Airworthiness Directive

AD No.: 2020-0191

ATA 25 – Equipment / Furnishings – Forward Facing Central Seat(s) – Removal

SERVICE BULLETIN**N° 139-633****ALERT****DATE:** August 5, 2020**REV. :** A - September 2, 2020

Figure 8

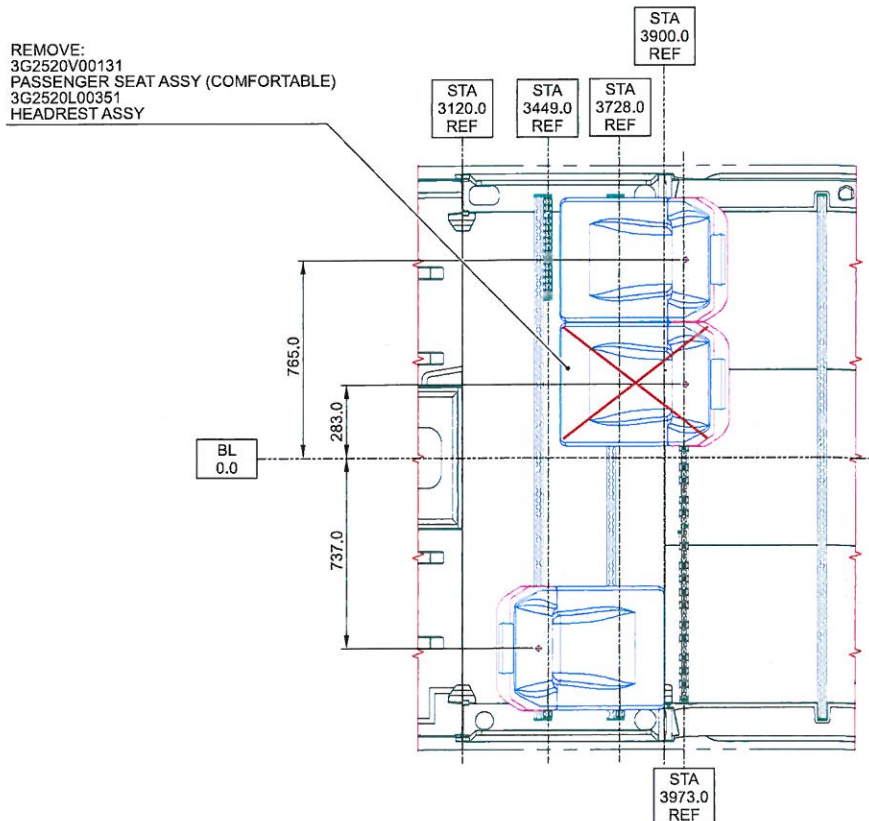
Revision A of this Service Bulletin has been developed to introduce kit P/N 3G2520F00611 (shown in newly added figures 1 and 8) among the affected configurations. Moreover, the illustration of “kit P/N 3G2520F00711 – REMOVAL” in Figure 9 has been changed, to amend a graphical error.

2. With reference to Figures 8 thru 13 and in accordance with AMP Section 25 applicable DM, remove the indicated 1st row central seat/seats (marked with a red X in the Figures).
3. In accordance with weight and balance changes, update the Chart A (see Rotorcraft Flight Manual, Part II, section 6).
4. Return the helicopter to flight configuration and record for compliance with this Service Bulletin on the helicopter logbook.
5. Send the attached compliance form to the following mail box:

Figure 9

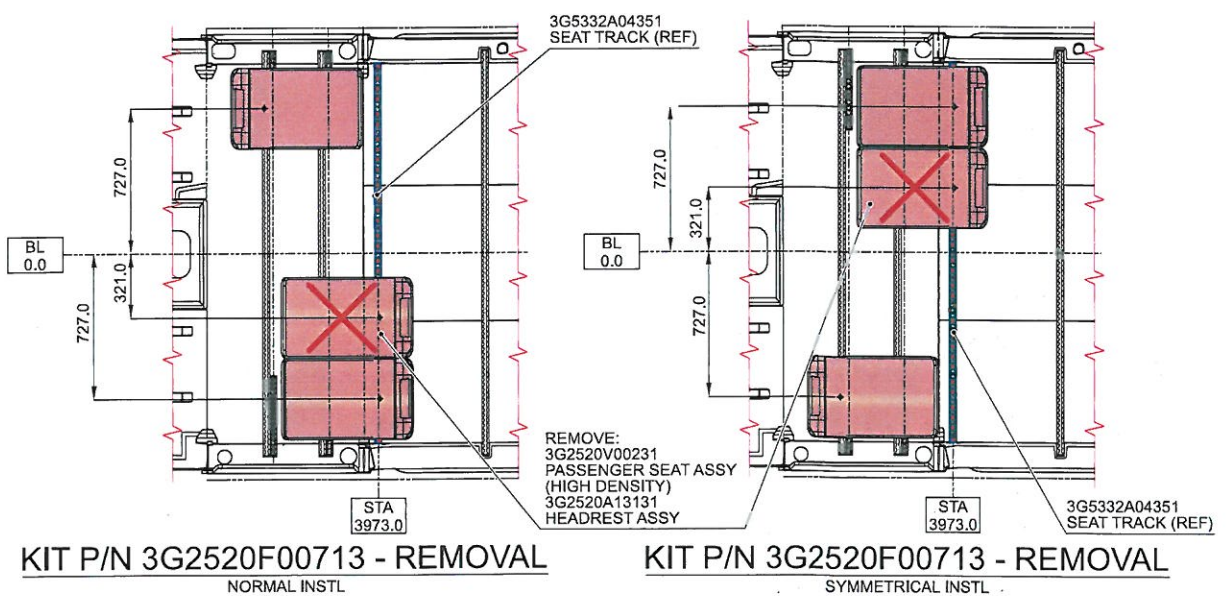
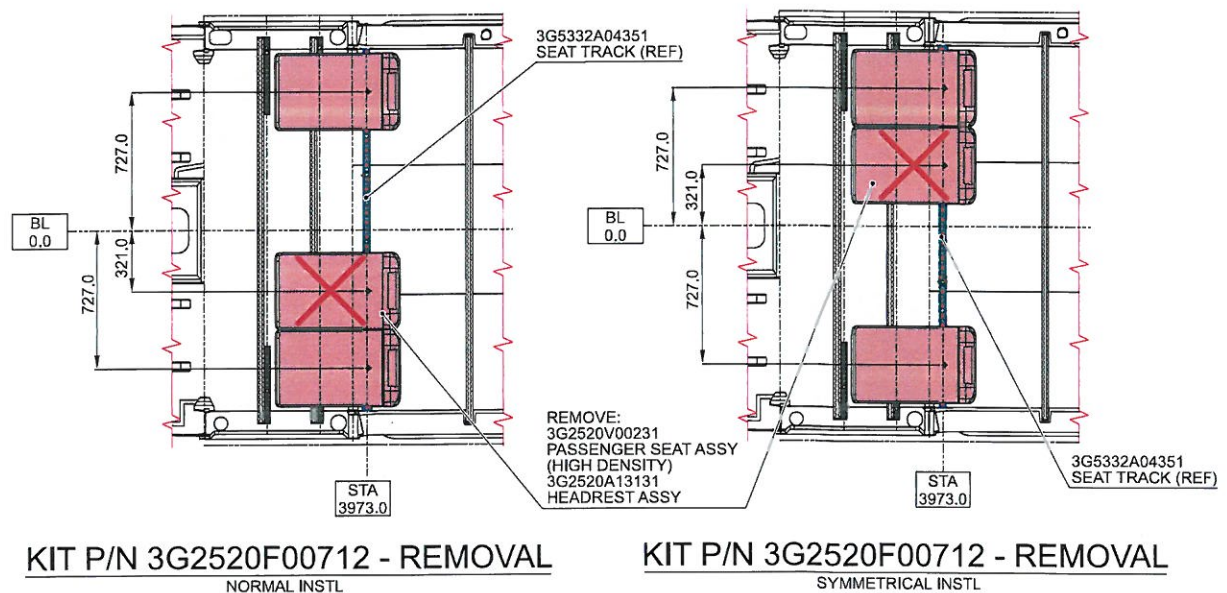
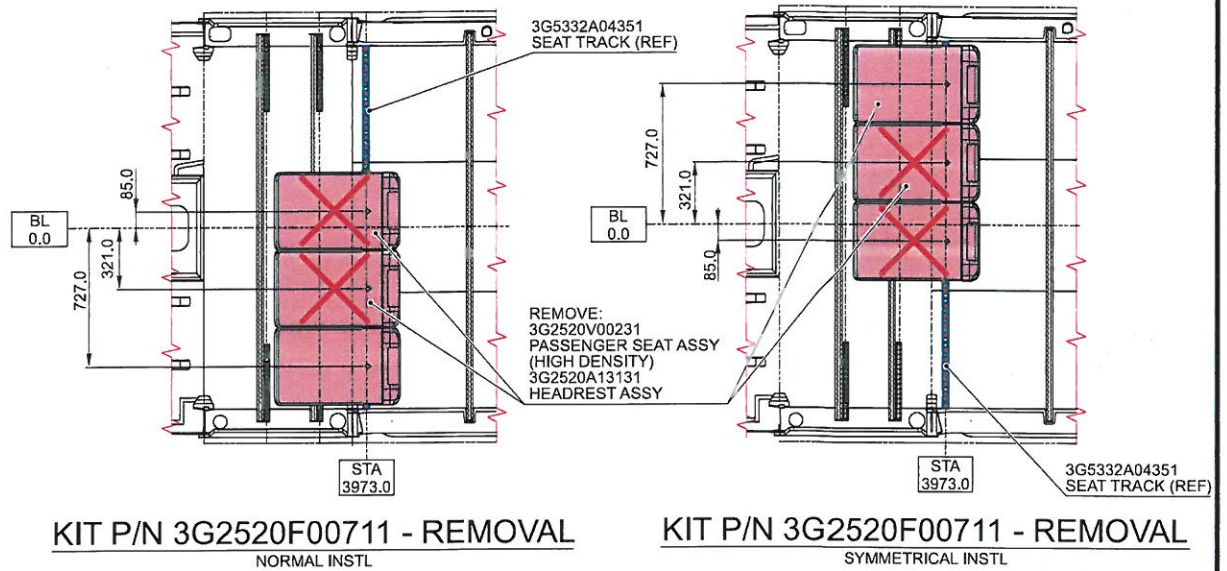
Helicopters that have complied with the first issue of this Service Bulletin have to check Figure 9 of Rev.A, to verify the correct seats configuration.
